ADDENDUM NUMBER: #1

Project Name: STARR COUNTY COURTHOUSE

TEMPORARY HOUSING INTERIOR BUILD-OUT

NOTICE TO ALL BIDDERS

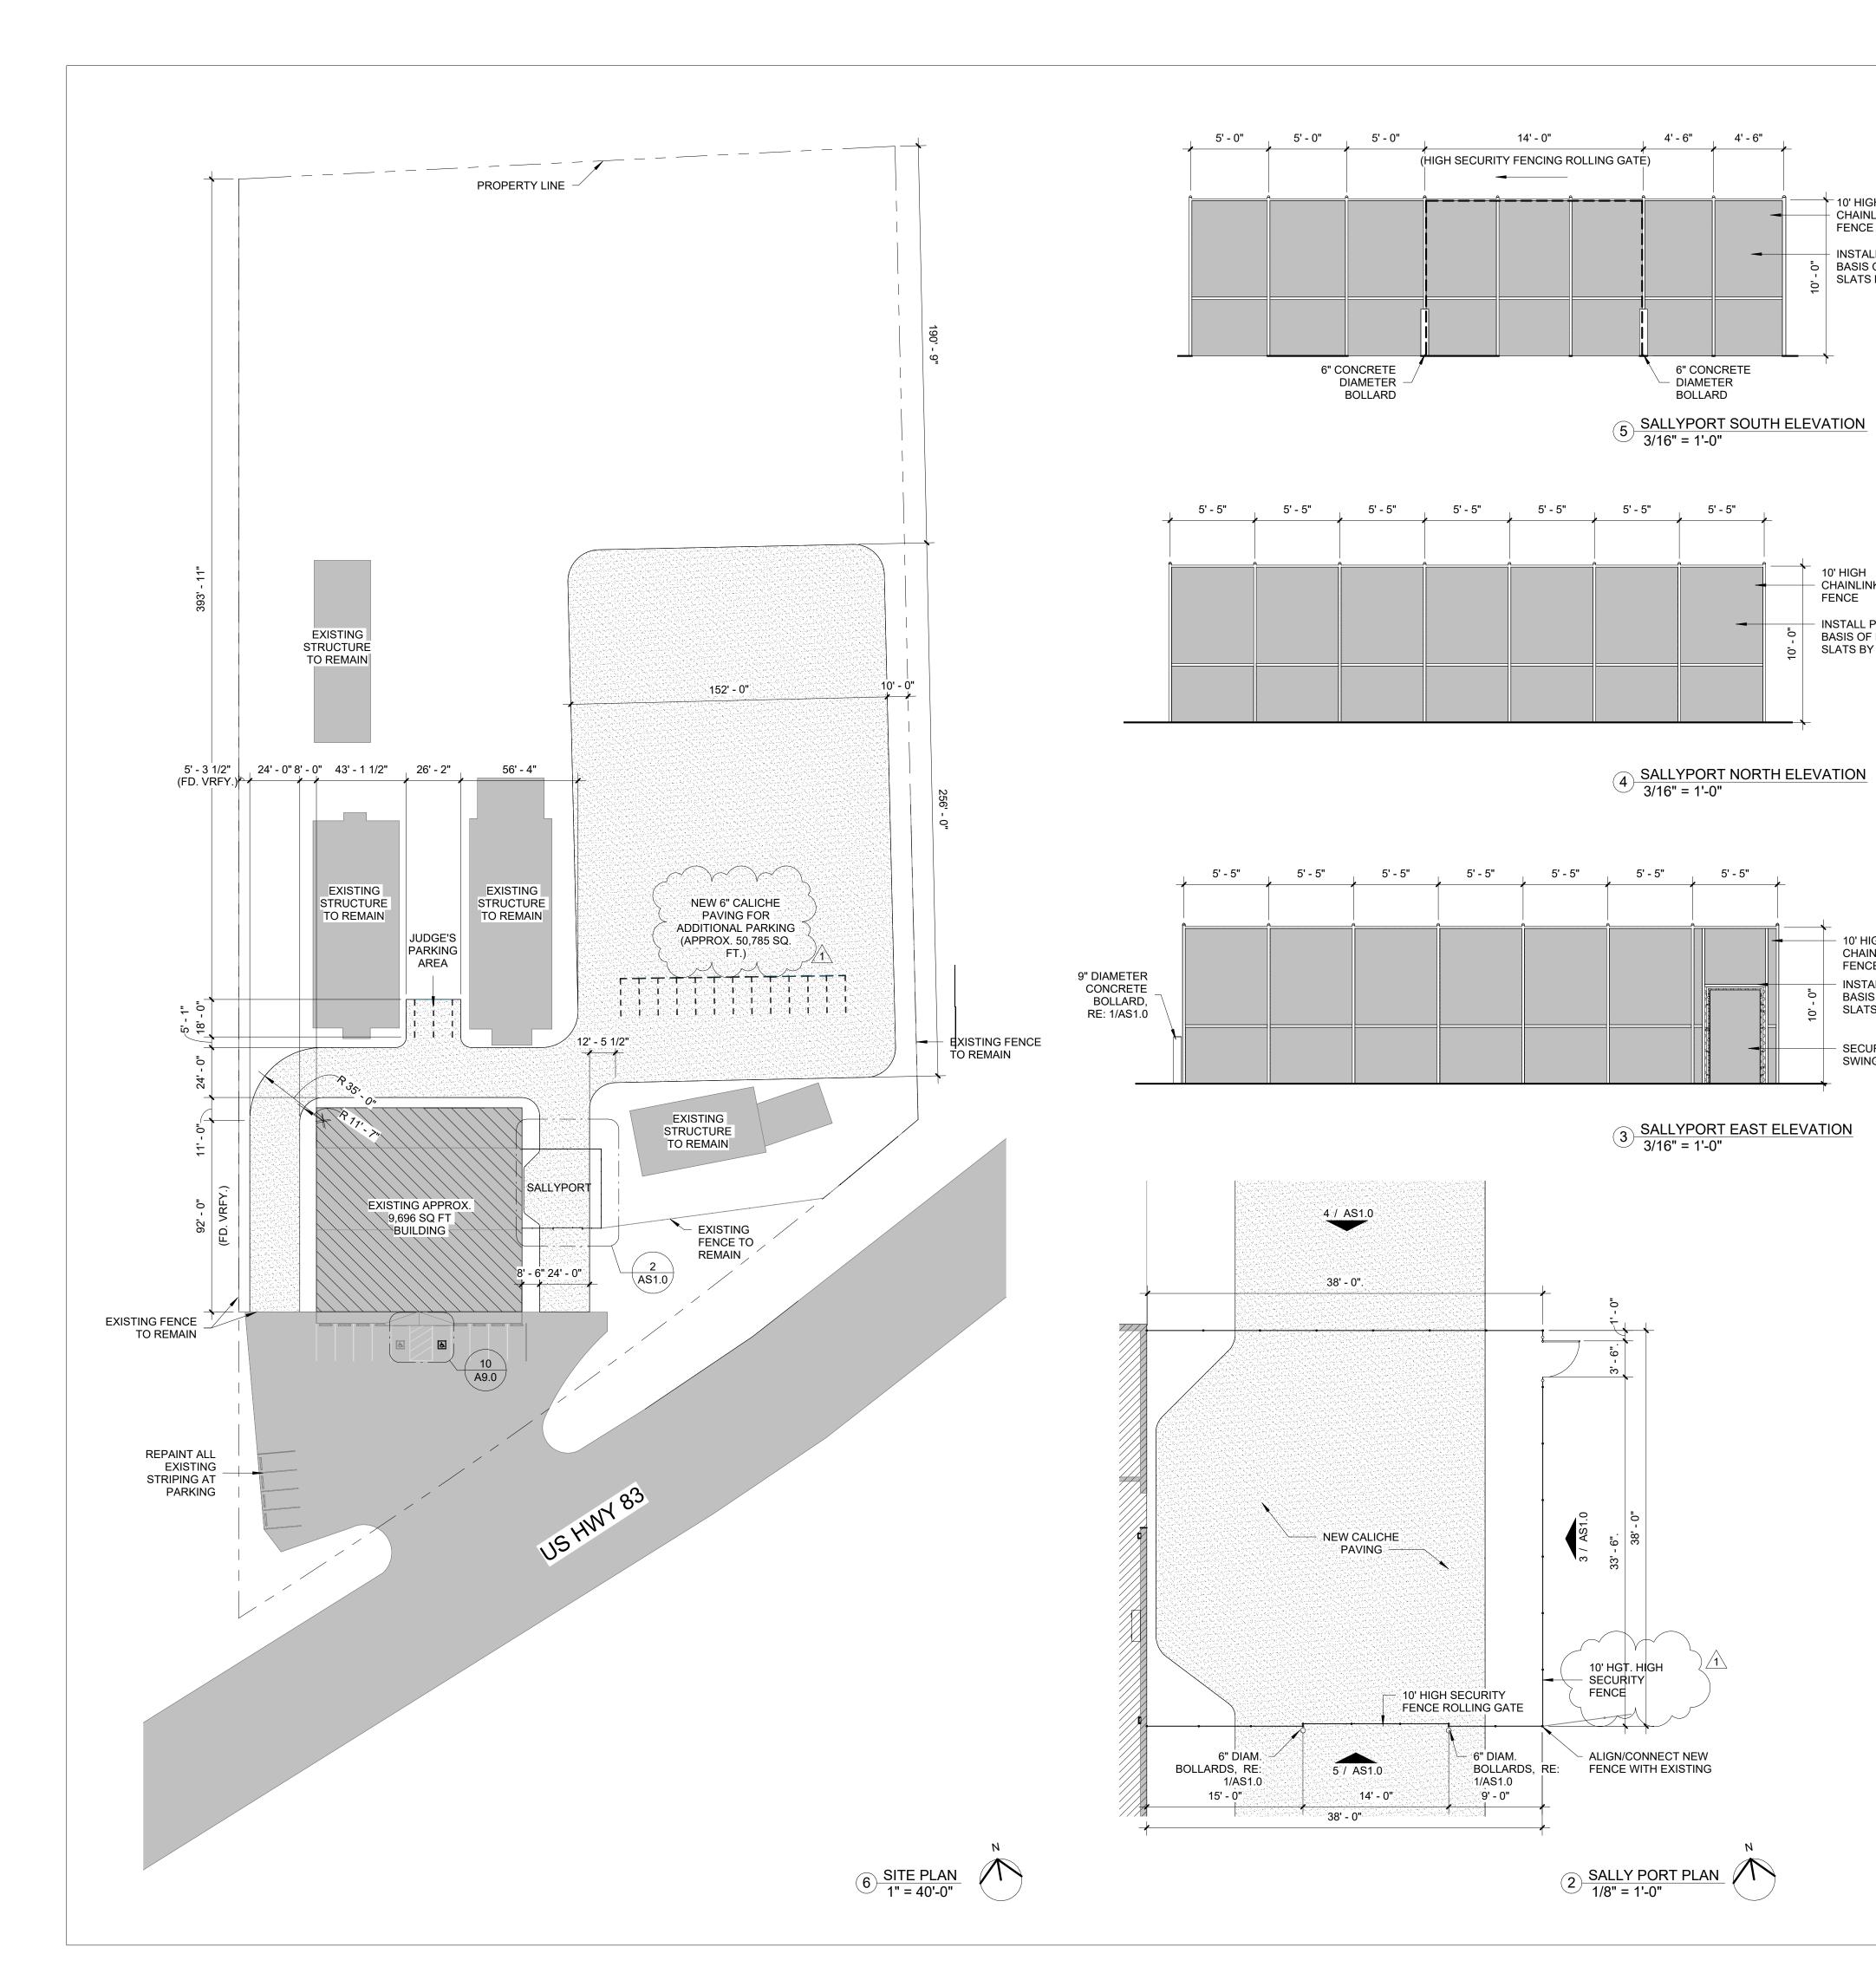
- 1.05 CORRECTION: Sheet A0.1- Egress Plan:
 - Revised Fire Protection notes & Code Summary

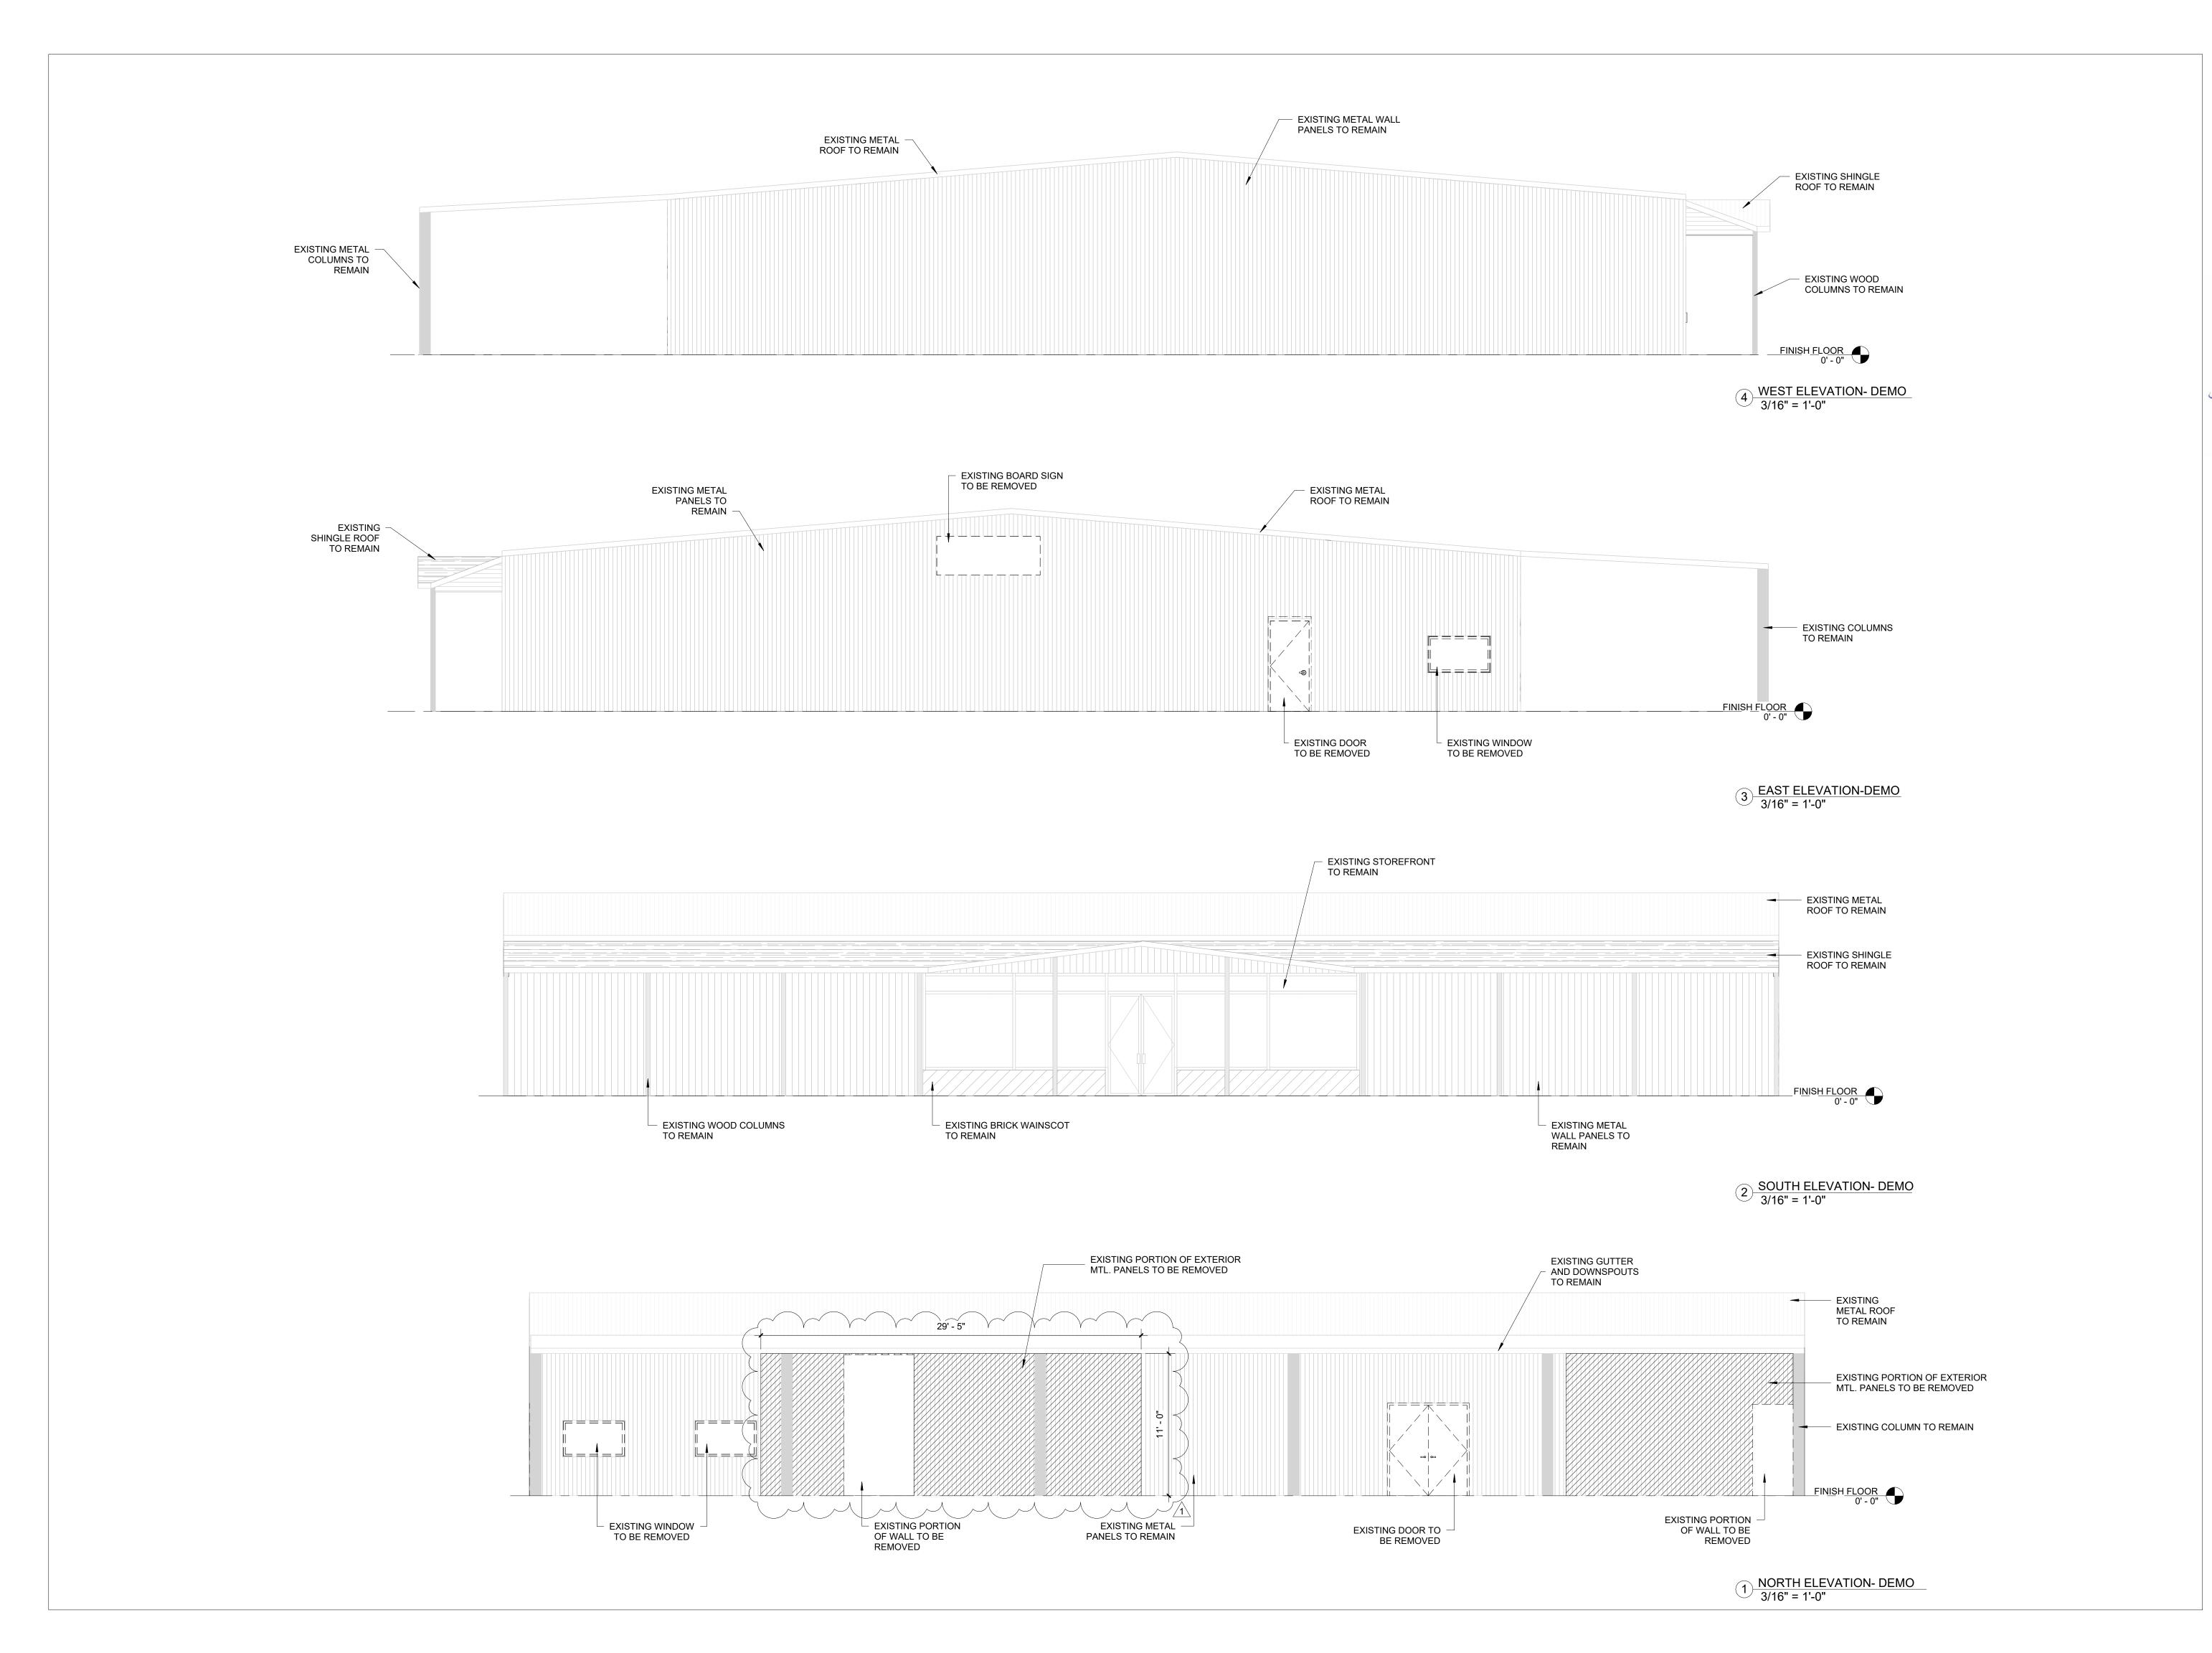
1.06 CORRECTION: Sheet AS1.0- Site Plan:

- Corrected security fence height notes at enlarged floor plan to 10'-0". Ref: 2/AS1.0
- Revised note for caliche to have a 6" depth

D2.0

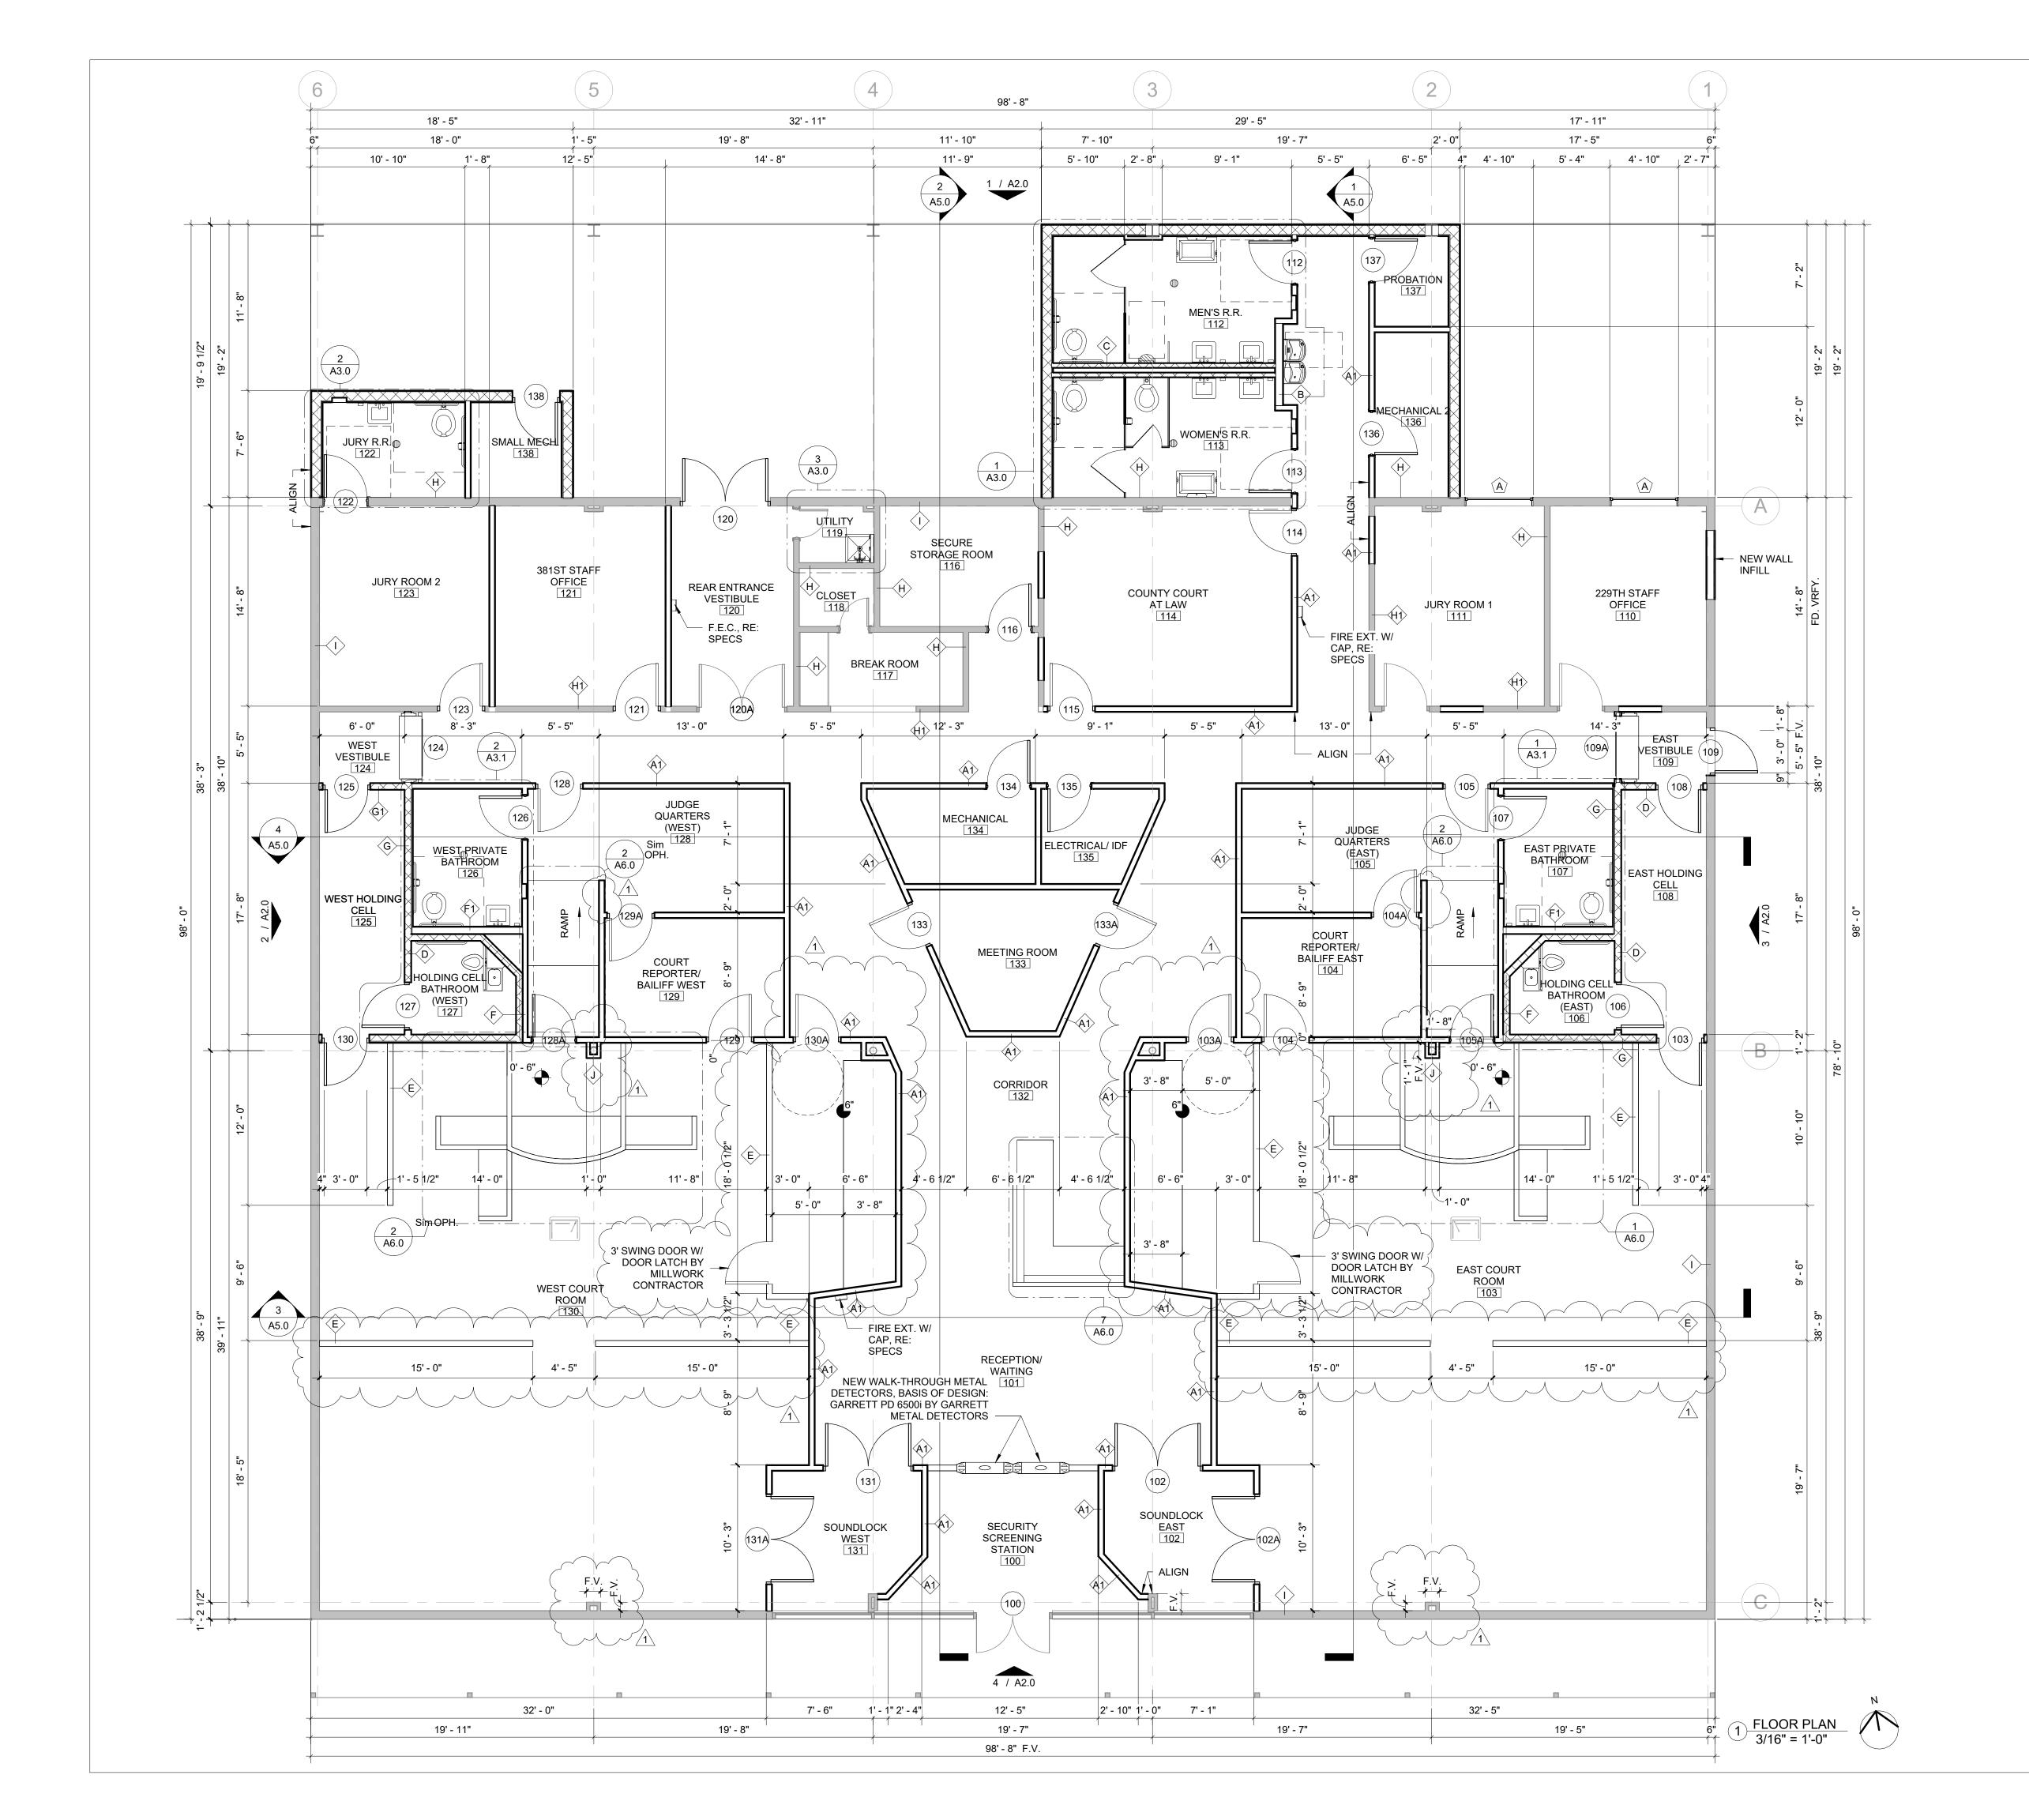
1.07 CLARIFICATION: Sheet D2.0- Demo Elevations:

• Noted portion of metal panels to be deleted at North Elevation
